Guelph/Eramosa Township Hydrogeology Agency Review Document Book

Hydrogeology Review Document Book Index

Re: Harden Response Letter Dated June 12, 2015
Project No.: 300032475.0000

**Re: JDCL Response to Hunter and Associates May 15, 2015 Peer Review
Project No.: 300032745.0000**

Fig 4.1

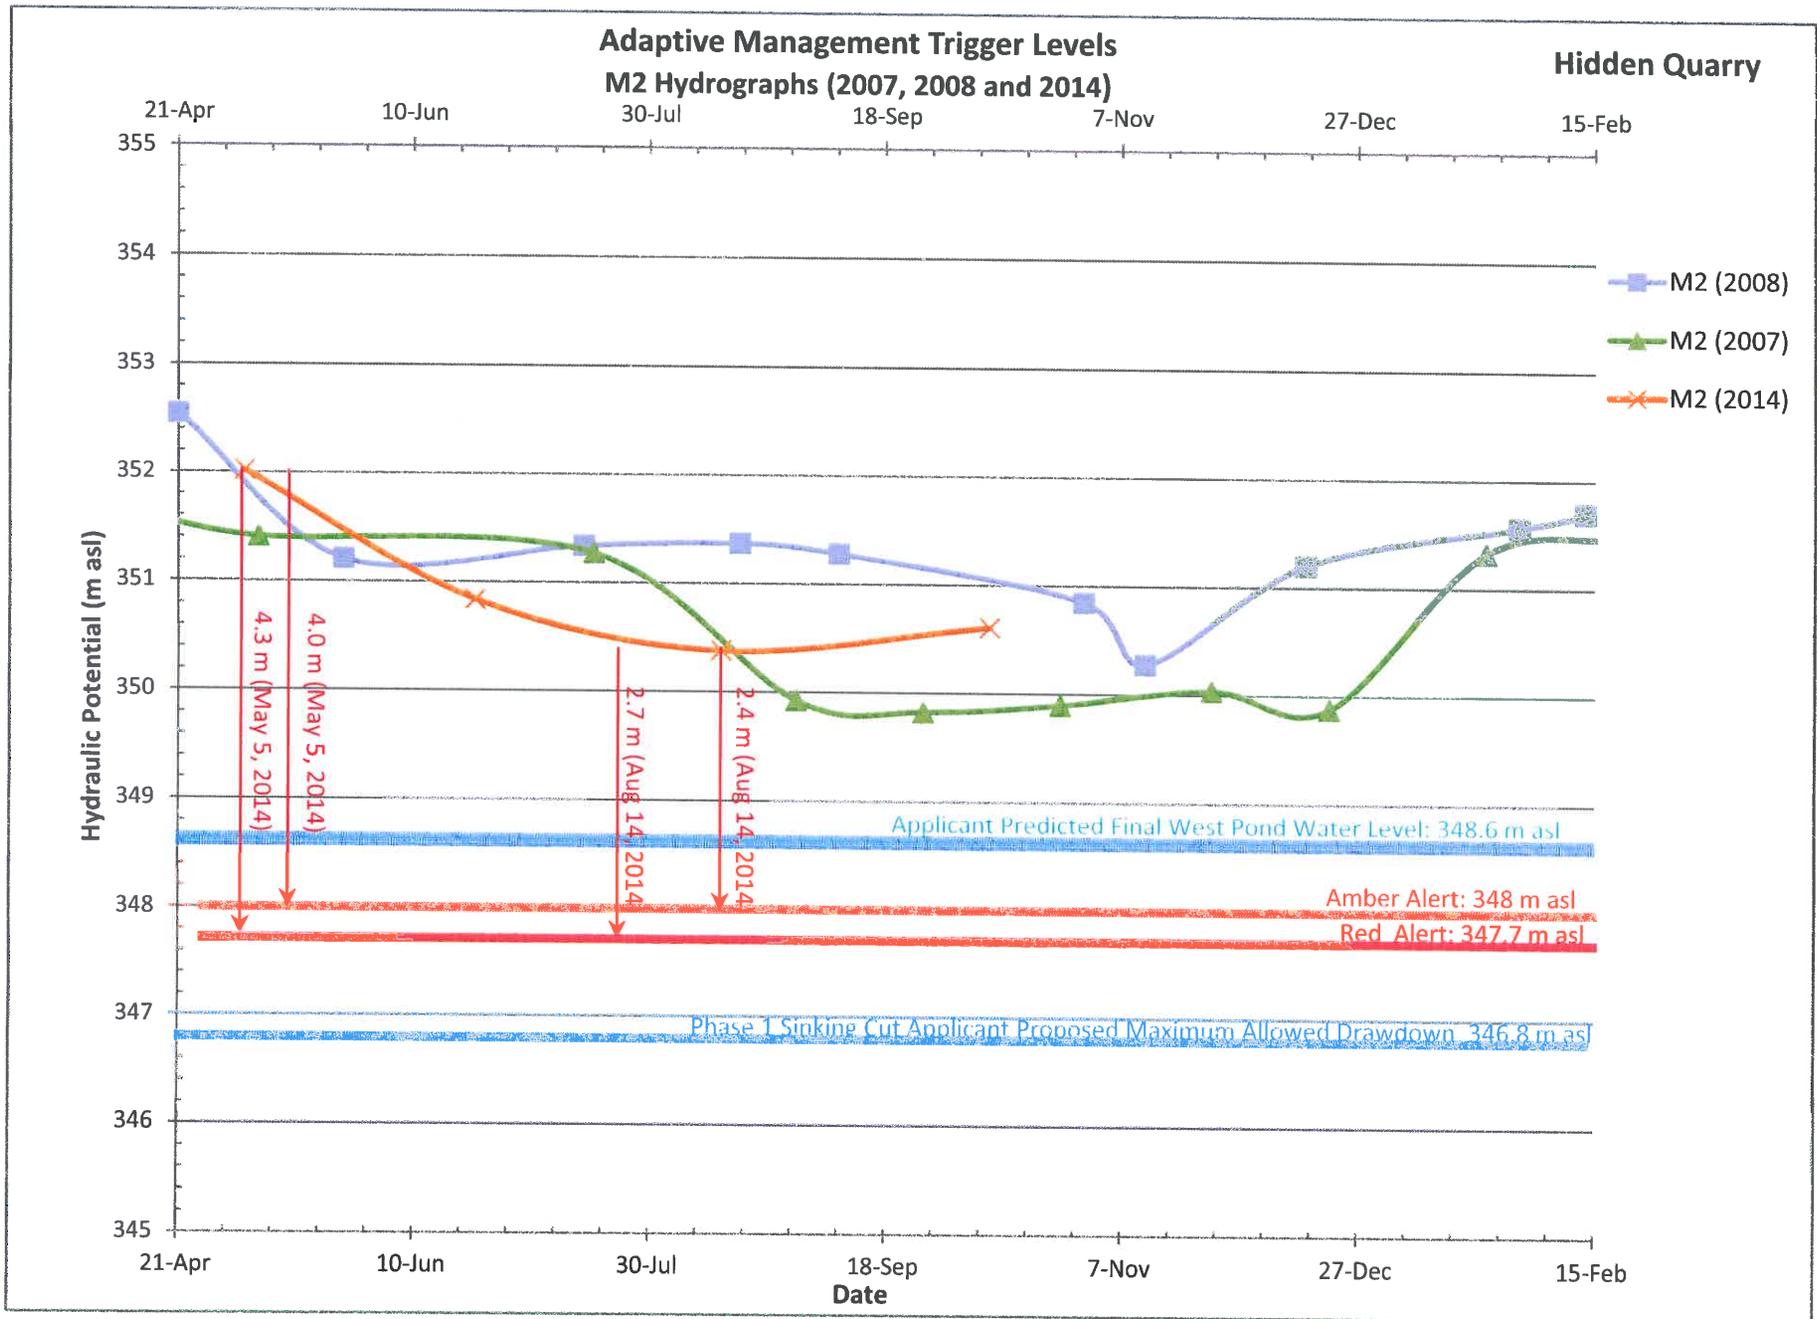
Fig 4.1 enclosed shows seasonal Amber and Red Alert hydrograph trend lines to provide early warning of dry season drawdown issues.

Fig 4.2

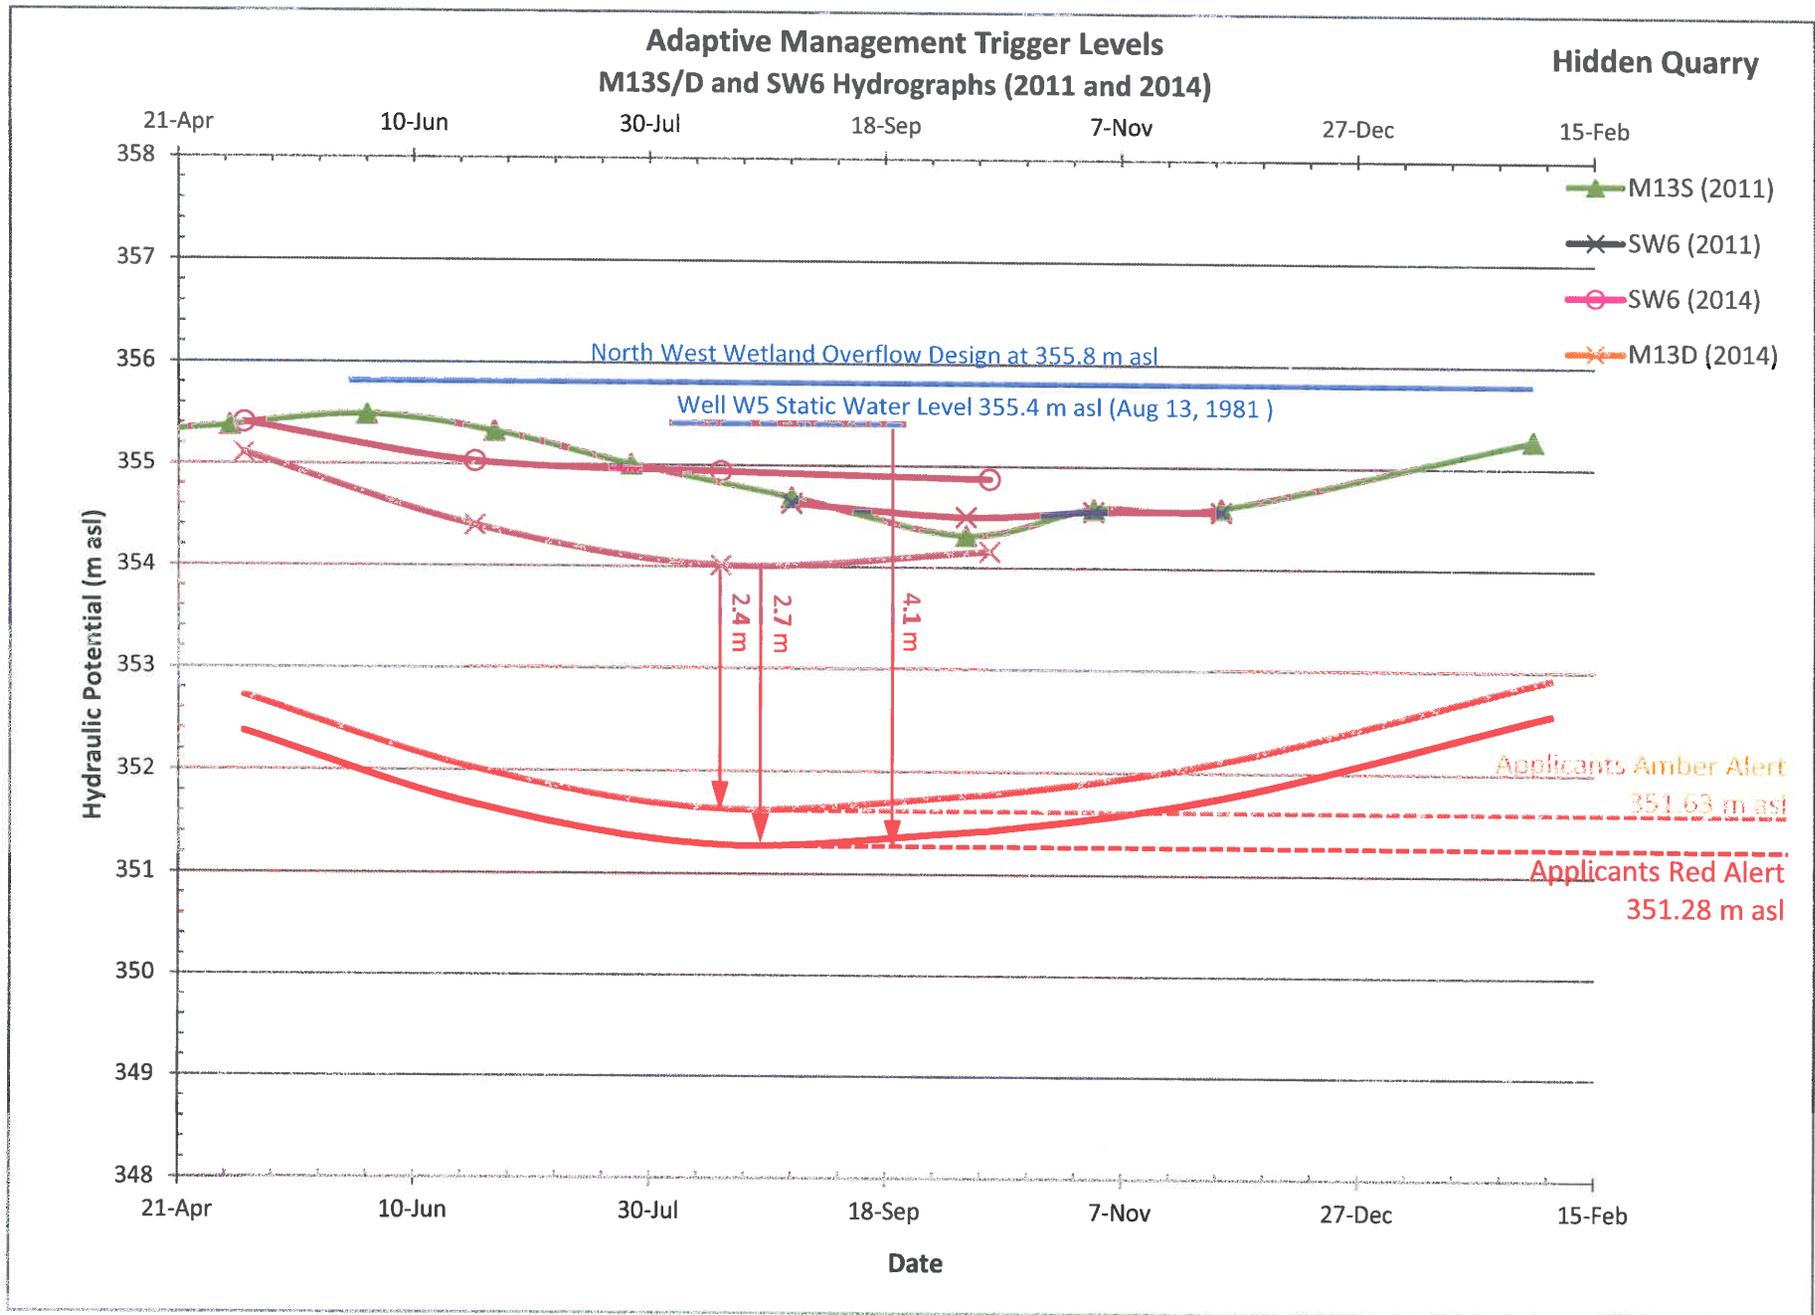
These Alerts have been adjusted downwards to reflect the operational Site Plan assumptions (Fig 4.2).

Fig 4.2 The M2 Adaptive Management Trigger levels are based on the Applicant's Site Plan proposed pit floor and operating water level drawdown requirements. The Amber Alert drawdown level in 2014 decreased from 4.0 m in May to 2.4 m in August.

Fig 4.3

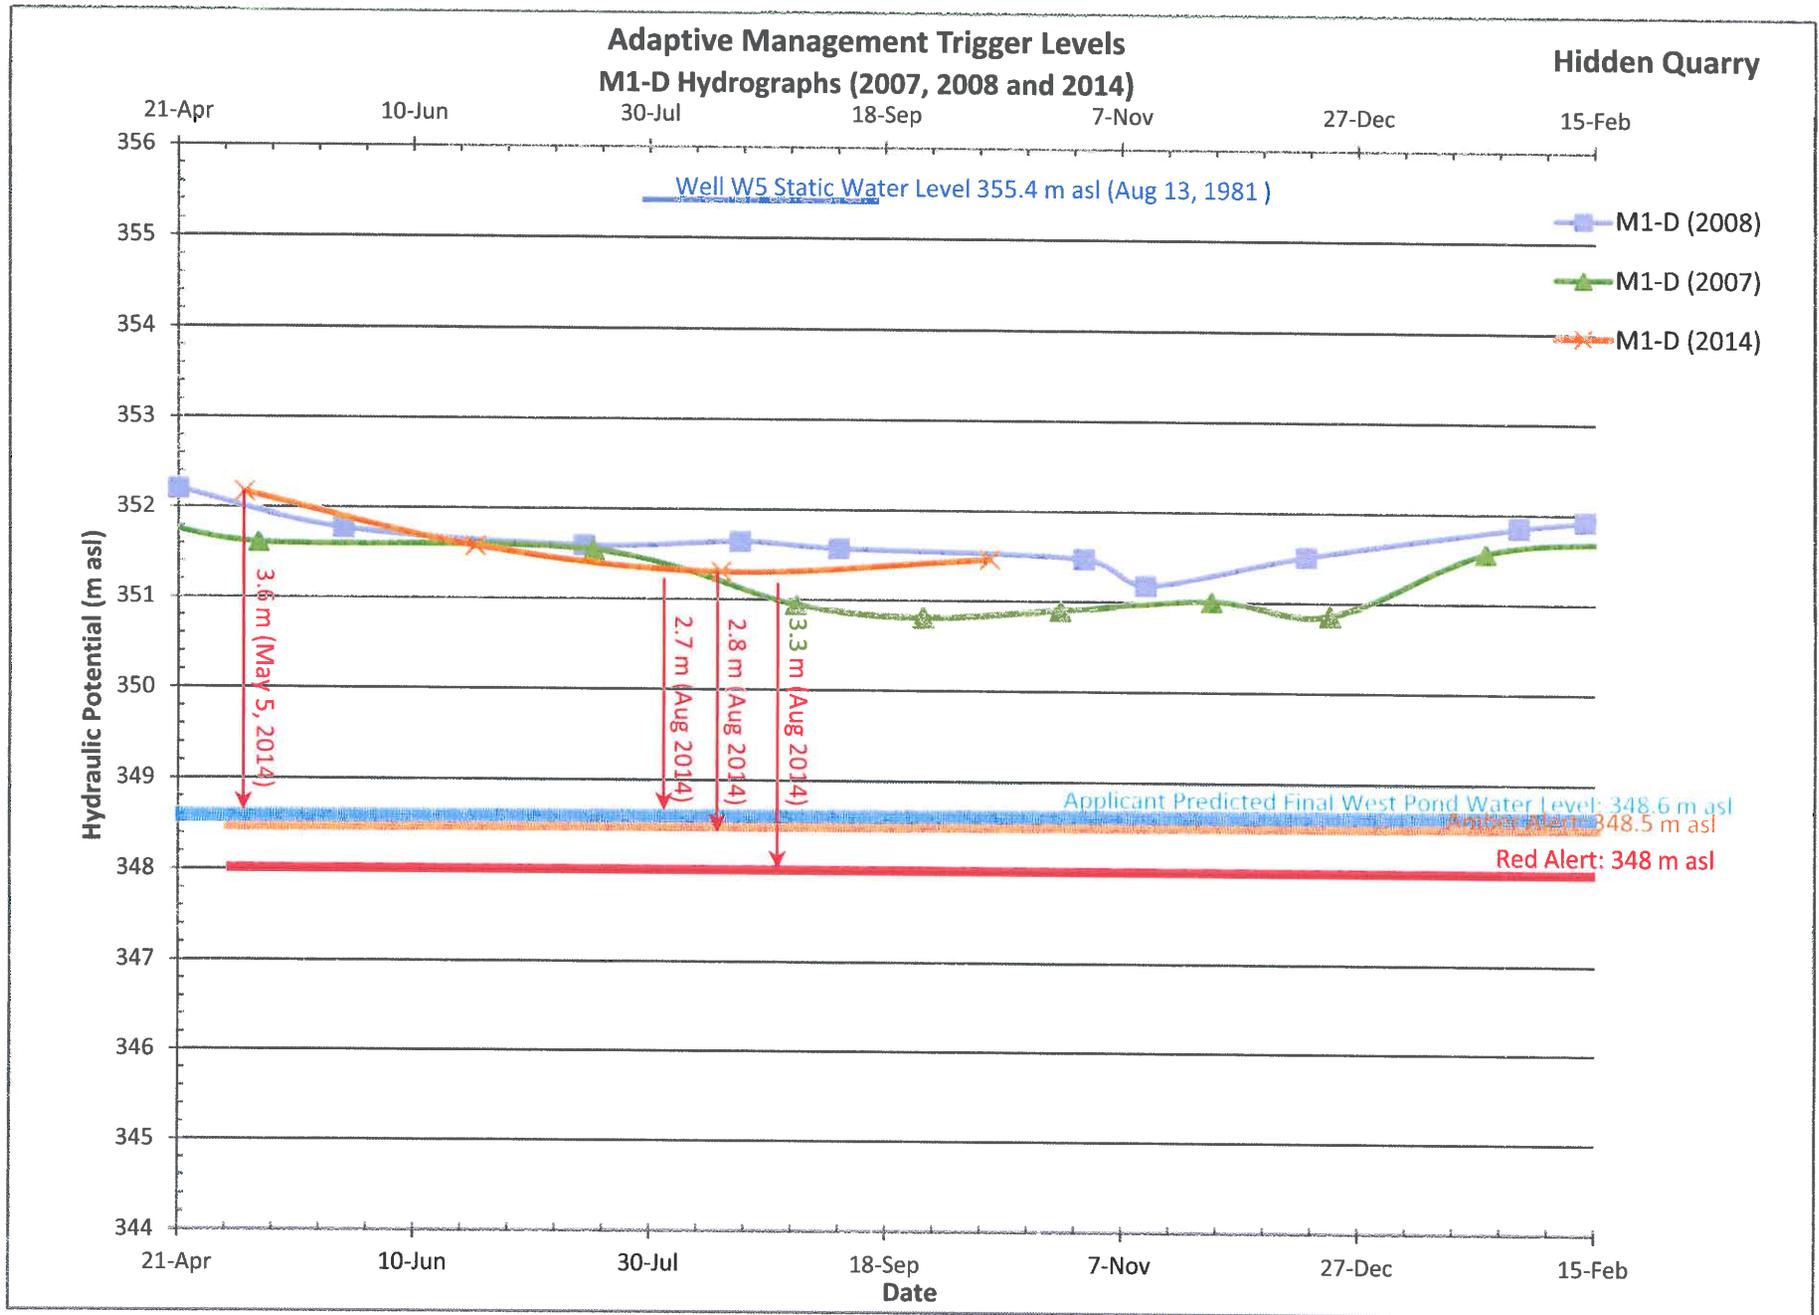
The Applicant has set the following trigger levels (Fig C.4, June 10, 2014) for M13D and pg 4 of 5 March 19, 2015 Site Plan version (Fig 4.3).

Fig 4.3 The Applicant proposed Amber and Red Alerts for Monitor Well 13D are plotted on this hydrograph. These alerts show a 4.1 m drawdown at nearby W5 based on static water levels at the time of W5 completion.
